STAFF REPORT
COMMUNITY DEVELOPMENT DEPARTMENT

HEARING DATE: August 6, 2020
 TO: Planning & Zoning Commission
 FROM: Sonya Allen, Associate Planner
 208-884-5533
 SUBJECT: H-2020-0074
 TM Center - PP
 LOCATION: East of S. Ten Mile Rd. & south of W. Franklin Rd., in the north half of Section 14, Township 3N., Range 1W.

Preliminary Plat consisting of 83 buildable lots and 2 common lots on 132.42 acres of land in the R-8, R-40, TN-C, C-C and C-G zoning districts.

STREET SECTION: S. WAYFINDER AVE.

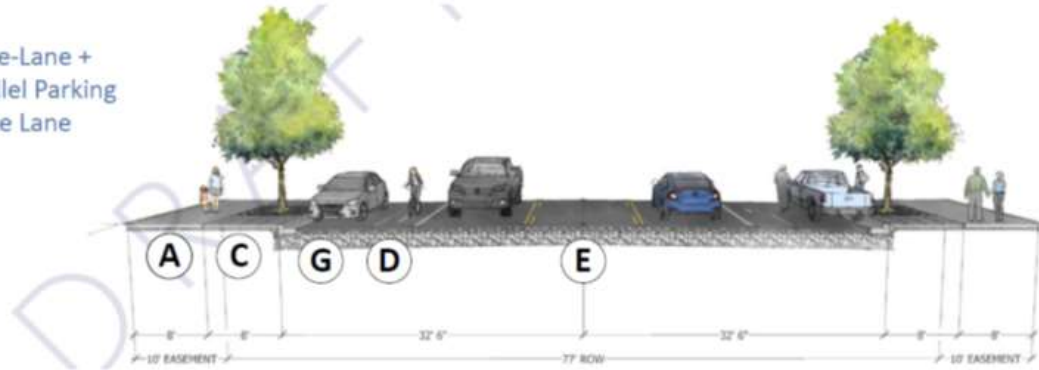
The proposed plat depicts a north/south collector street (S. Wayfinder Way) in alignment with that shown on the Street Section Map and the MSM. The street section from the plat and a detail is shown below consistent with a towncenter collector street and generally consistent with Street Section E except that it has a center turn lane and on-street parallel instead of diagonal parking. This section may be modified to allow parallel parking as a local section in these areas; parallel parking was allowed in the section of Wayfinder north of the Ten Mile Creek bridge. **Staff is amenable to parallel parking being provided in this section of Wayfinder consistent with that to the north if determined appropriate by City Council.** *Note: Construction plans for completion of this street were submitted to ACHD earlier this year and have been approved per the ACHD report.*

2. The final plat(s) shall include the following revisions:
 - a. South Wayfinder Ave. shall be constructed consistent with the street section in Section VIII.A in accord with Street Section E in the TMISAP and shall include pedestrian-scale lighting. A 5-foot dry-utilities corridor should be provided along both sides of the street curb. Both wet utilities may be located in the street. Streetlights should be placed in the dry utilities corridor on either side of the street.

STREET SECTION: S. NEW MARKET AVE.

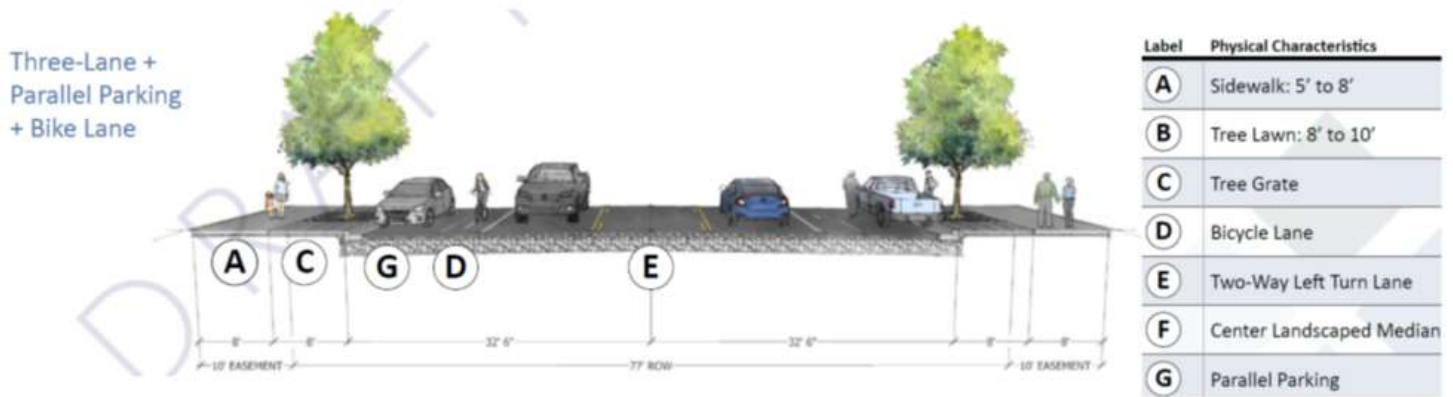
The proposed plat depicts a north/south collector street (S. New Market Ave.) in alignment with that shown on the Street Section Map and MSM. **The street section from the plat and a detail is shown below consistent with a towncenter collector street. ACHD has approved the street to be constructed as a towncenter collector street consistent with the MSM although the MSM designation differs from that on the Street Section Map in the TMISAP, which is a residential collector street. Staff recommends the detached sidewalk on the east side of New Market is constructed as a 10' multi-use pathway in accord with the Pathways Master Plan and buffers are constructed at the back edge of the sidewalk/pathway where residential uses are proposed along the street consistent with that depicted on Street Section D. Where residential uses are *not* constructed along along the street, a 12' sidewalk/pathway with tree grates should be constructed.**

- b. South New Market Ave. shall be constructed consistent with the street section in Section VIII.A except that a 10-foot wide multi-use pathway shall be provided along the east side of the street

consistent with the Pathways Master Plan and landscaped buffers shall be provided at the back edge of the sidewalk/pathway in accord with Street Section D in the TMISAP where residential uses are developed along the street. If non-residential uses are developed along the street, a 12-foot wide sidewalk/pathway with tree grates and pedestrian-scale lighting shall be constructed instead. A 5-foot dry-utilities corridor should be provided along both sides of the street curb. Both wet utilities may be located in the street. Streetlights should be placed in the dry utilities corridor on either side of the street.

STREET SECTION: W. COBALT DR.

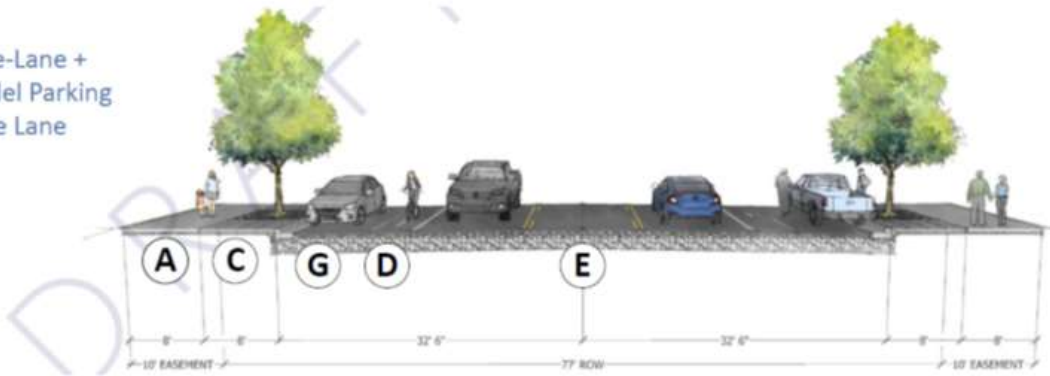
The Street Section Map shown above, nor the MSM, depicts an east/west collector where W. Cobalt Dr. is proposed to extend between Wayfinder and New Market although it does depict such further to the south in alignment with the access via Ten Mile Rd. along the southern boundary of this site which was actually constructed further to the south (i.e. Navigator Dr.) as discussed above. This southern section is designated as a minor collector street (“E”) on the Street Section Map in the TMISAP and as a towncenter collector on the MSM. The portion of Cobalt west of Wayfinder is designated as a residential collector street (Street Section D). The proposed street will provide a connection from Ten Mile between Wayfinder and New Market which Staff believes provides more connectivity in this area as desired.

The street section from the plat and a detail is shown below consistent with a towncenter collector street. This segment of Cobalt was previously approved as part of ACHD’s action on the TM Creek East Apartments that’s currently under construction. A buffer area was depicted on the landscape plan for the apartments project on the north side of the street at the back edge of the sidewalk consistent with Street Section D for residential collector streets; this should be continued to the east (and south if applicable) with future residential projects.

- c. West Cobalt Dr. shall be constructed consistent with the street section in Section VIII.A except that landscaped buffers shall be provided at the back edge of the sidewalk/pathway in accord with Street Section D in the TMISAP where residential uses are developed along the street. If non-residential uses are developed along the street, a 12-foot wide sidewalk/pathway with tree grates and pedestrian-scale lighting shall be constructed instead. A 5-foot dry-utilities corridor should be provided along both sides of the street curb. Both wet utilities may be located in the street. Streetlights should be placed in the dry utilities corridor on either side of the street.
